Network Working Group
Request for Comments: 1151
Updates: RFC 908

Version 2 of the Reliable Data Protocol (RDP)

RDP Header Format
Figure 1

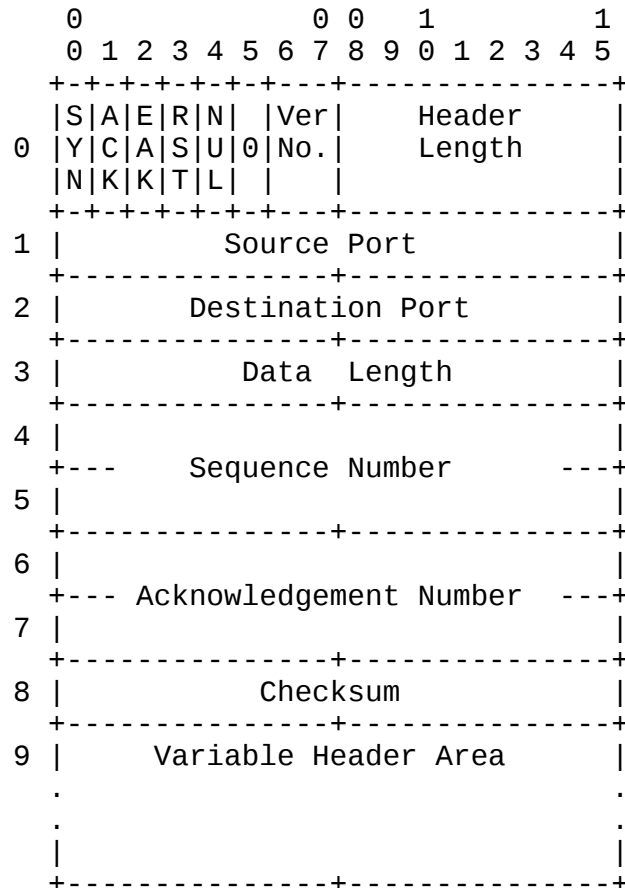
There are three changes to the protocol header: the checksum algorithm has been changed, the port size increased, and the version number incremented. The new header format is shown in Figure 1.

The wide variation in performance on comparable machines was felt to be undesirable, so the checksum has been changed. RDP now uses the 16-bit TCP checksum, which is specified on page 16 of RFC-793.

The 8-bit port size is probably too small to support a large range of applications. Accordingly, the port size is now 16-bits. Port numbers less than 1024 are reserved for well-defined applications. Allocable ports begin at port number 1024.

Finally, because the checksum and port size have been changed, the version number has been increased to 2.
